County of Fairfax, Virginia

STAFF REPORT ADDENDUM

RZ/ FDP 2009-HM-019
(Concurrent with DPWES Waiver #2615-WPFM-002-1)

APPLICANT: Comstock Reston Station Holdings, LC

Graphic 2: Public Plaza Ingress and Egress Exhibit

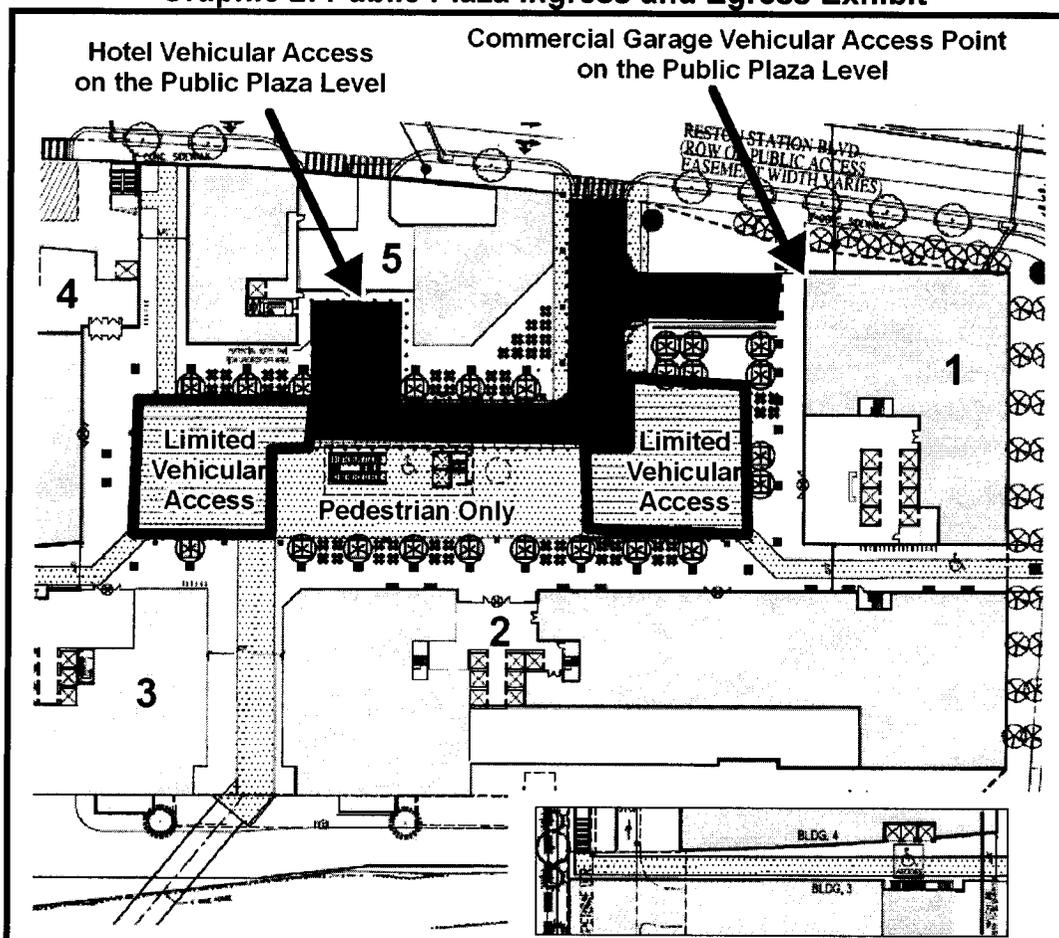
In response to these concerns, the applicant has revised Sheets 11A and 11B of the CDP/FDP (the proposed plaza ingress and egress exhibit for the initial phase and the build-out phase) to show: areas on the public plaza that would be closed to non-emergency vehicles during public events; a restricted access to the commercial garage on the public plaza (with a right in/ right out only on the northeast side of Building 1); and vehicle access, including two potential taxi stands at the drop off area on the south side of Building 5 (proposed to be a hotel building). Graphic 2 shows these areas for the build-out phase. (The same general areas are proposed to be closed to non-emergency vehicles during the initial phase.)

As shown in Graphic 2, a portion of the public plaza (highlighted in black) is proposed to remain fully open to vehicles during most public events. Two portions of the public plaza located to the west and east of the hotel drop-off area are proposed to have limited vehicular access during public events. The remaining areas on the public plaza would be pedestrian only at all times.

In addition, the applicant revised Proffer 40C, which now commits to the creation of a Plaza Management Plan, commencing with the initial phase of development, to restrict and/or control vehicular access to the public plaza; this plan would be submitted and approved by Fairfax County Department of Transportation (FCDOT) and the Zoning Administrator.

DATE: 11/11/09
 SCALE: 1" = 40'
 SHEET: 11
 TOTAL: 12

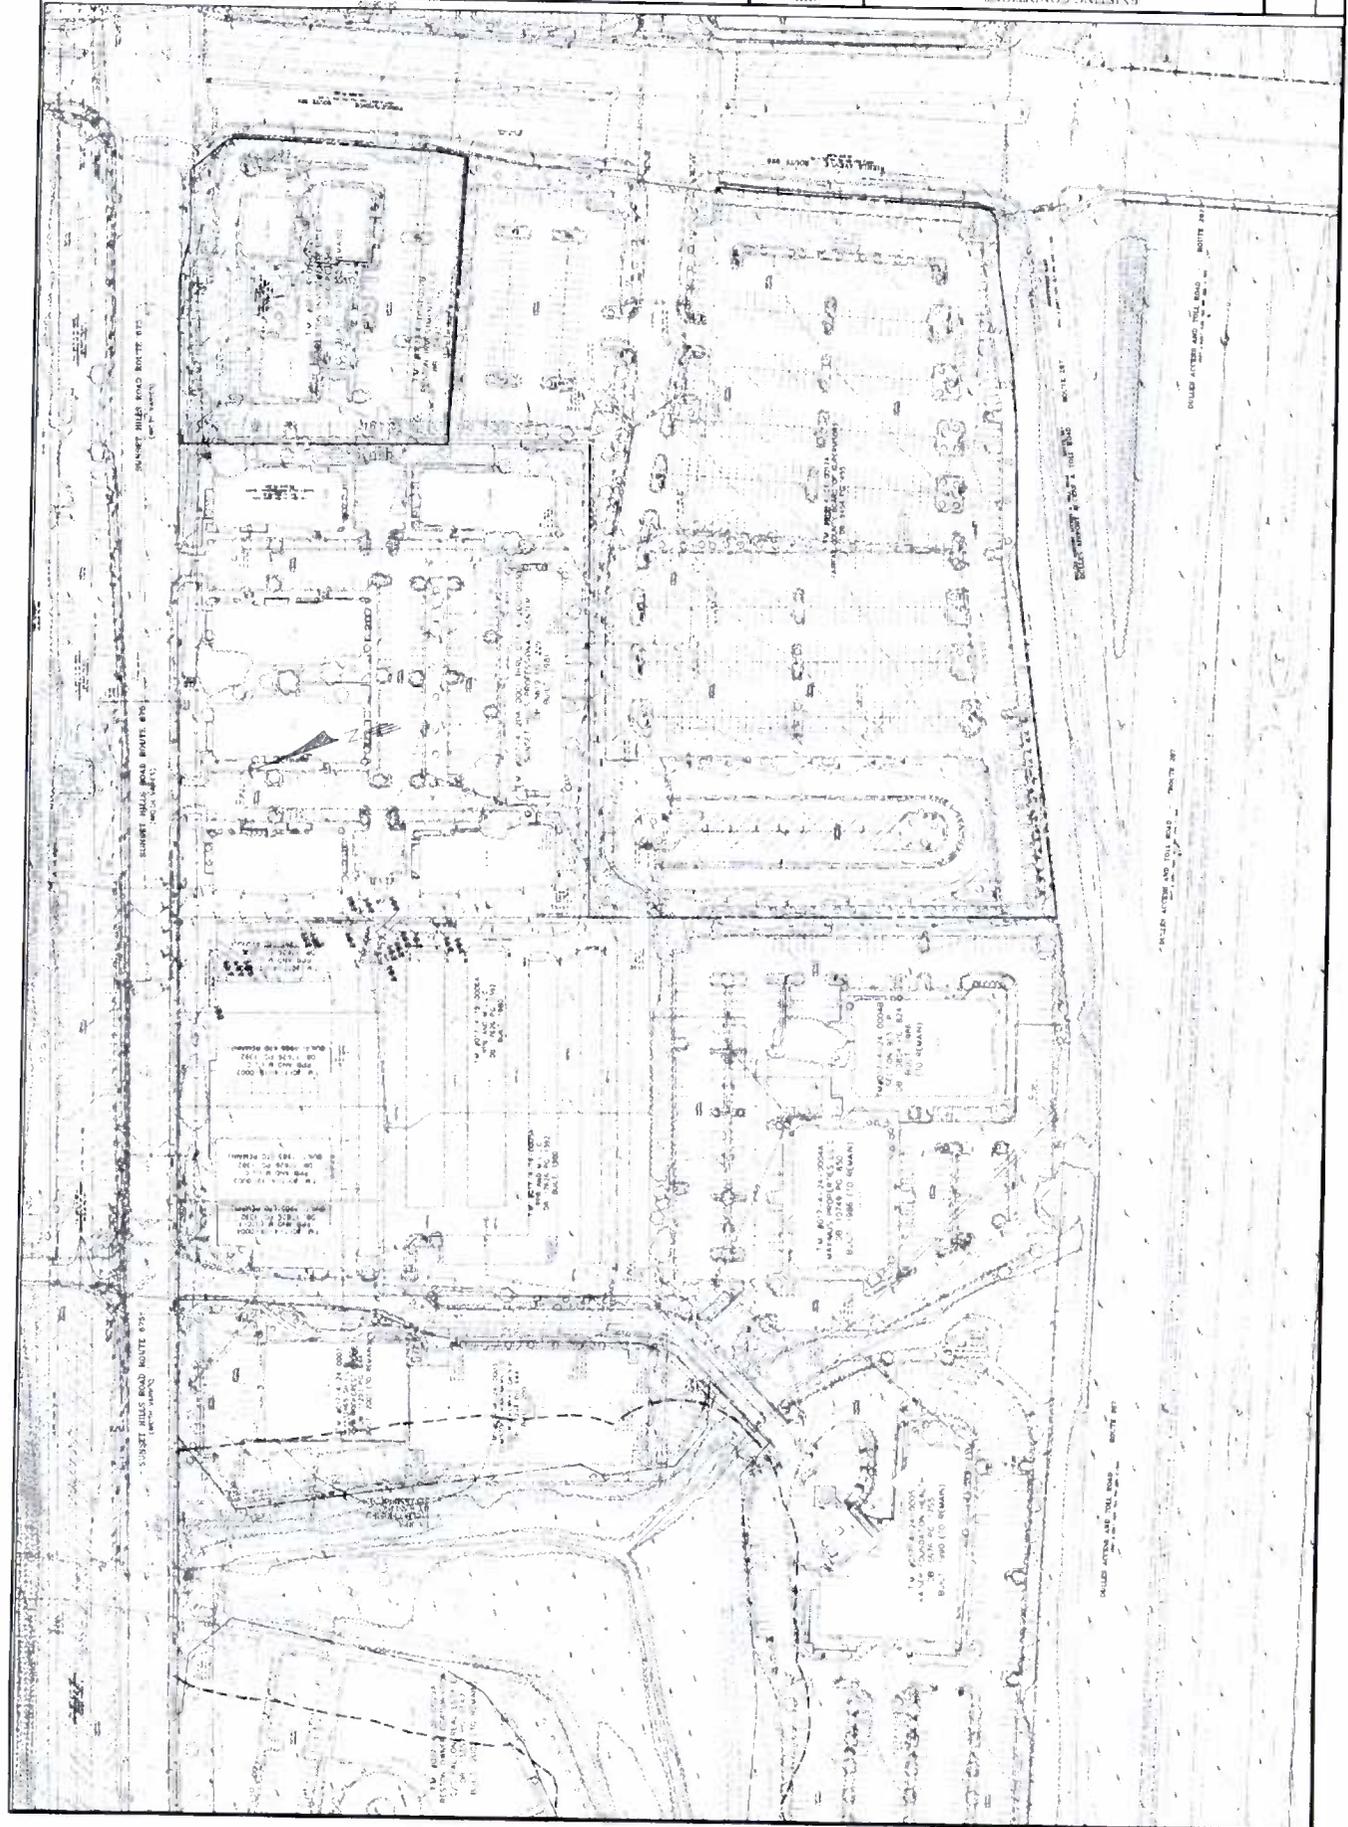
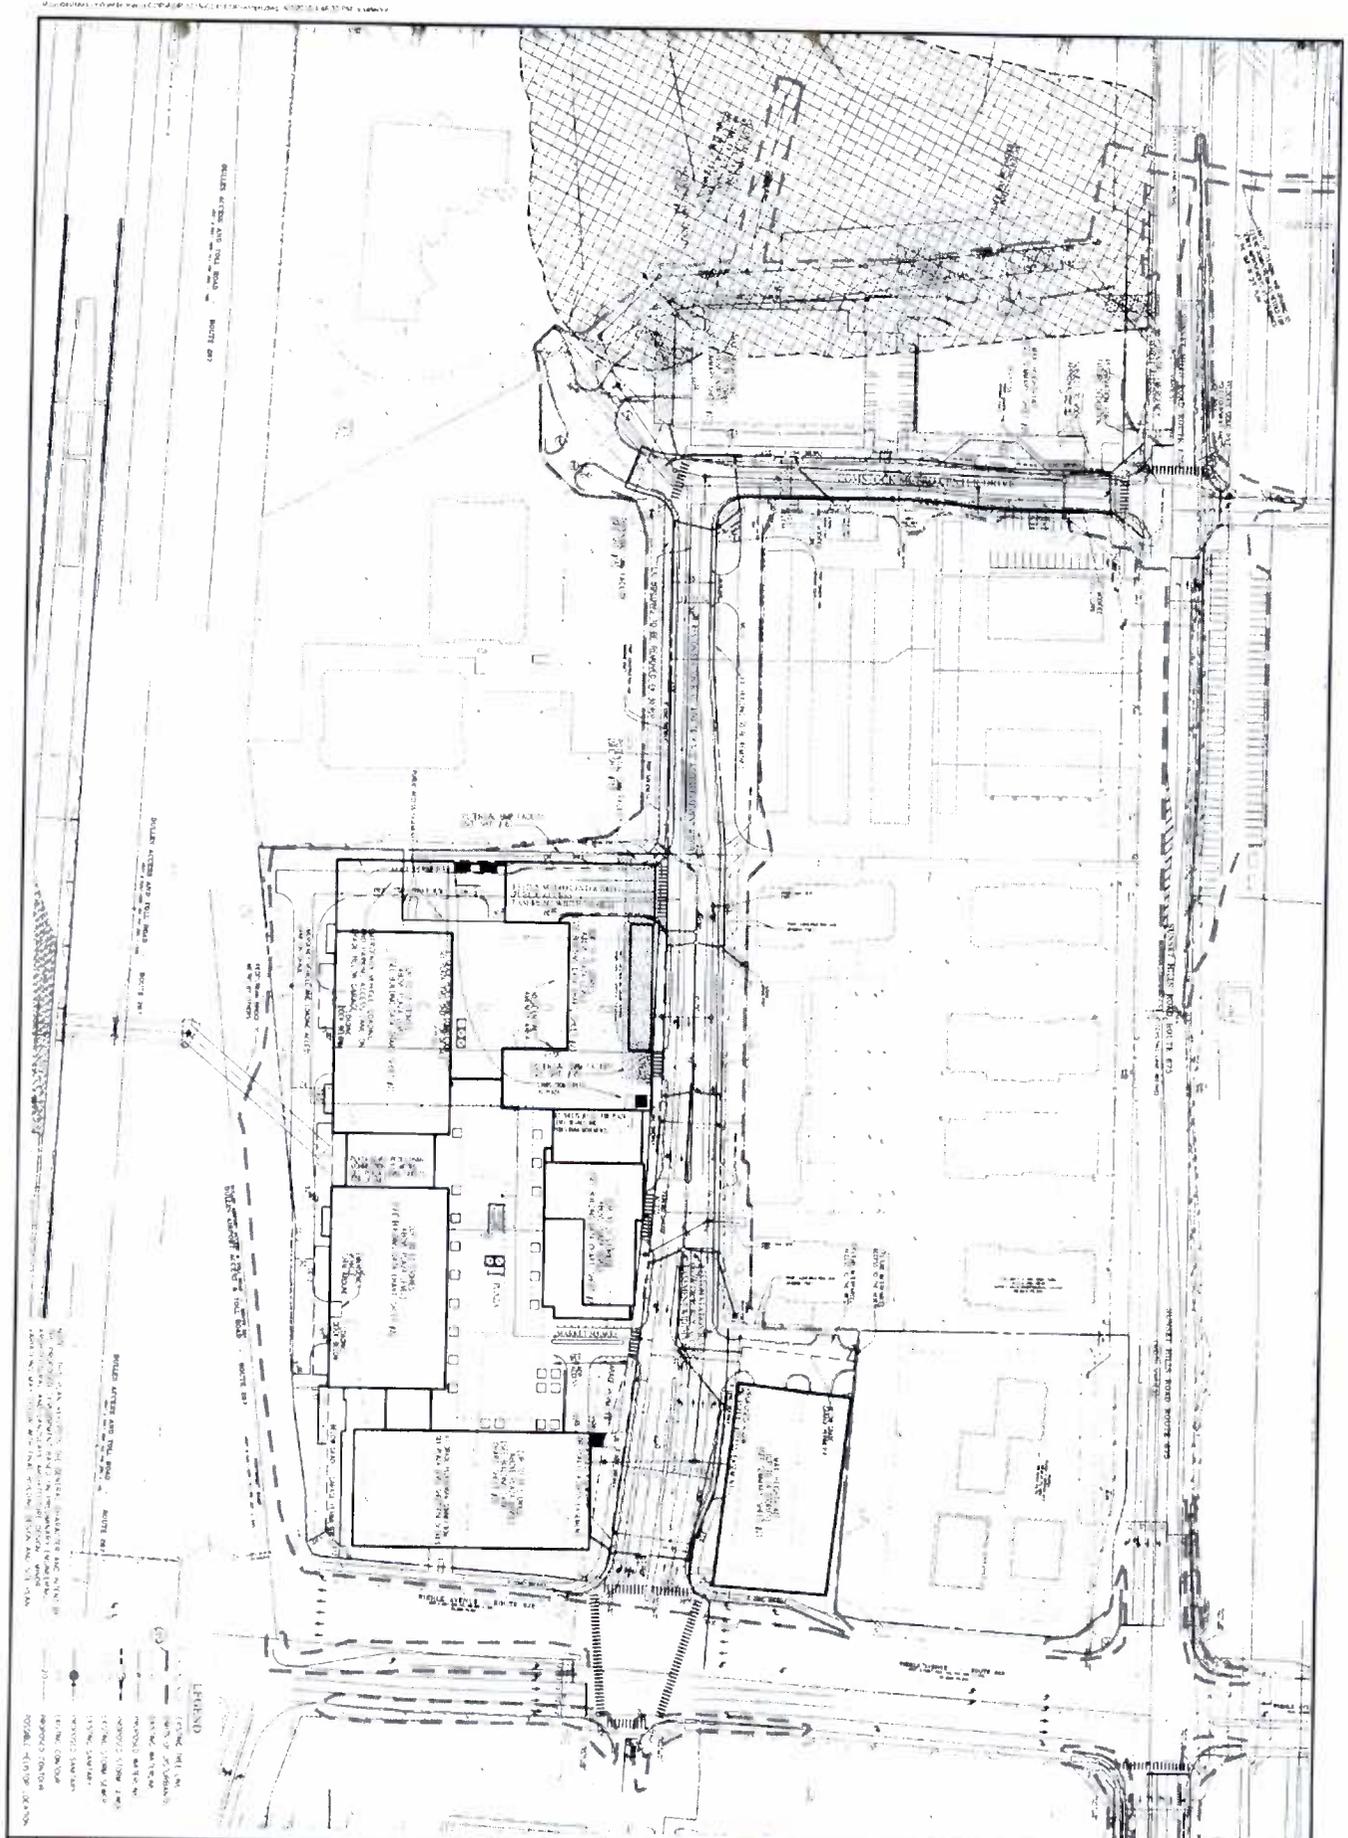
- vehicular access may be provided between 8:00 pm and 1:00 am on weekdays, weekends and on federal holidays only to that area shown on Sheet 11A and Sheet 11B of the CDP/FDP as "area which may remain open to vehicles during public events." As an alternative to this location, vehicular access may be provided to an area defined by the plaza entrance from Reston Station Boulevard south to include the vehicle turnaround depicted on Sheets 11A and 11B. At no time shall both of these areas be open together.
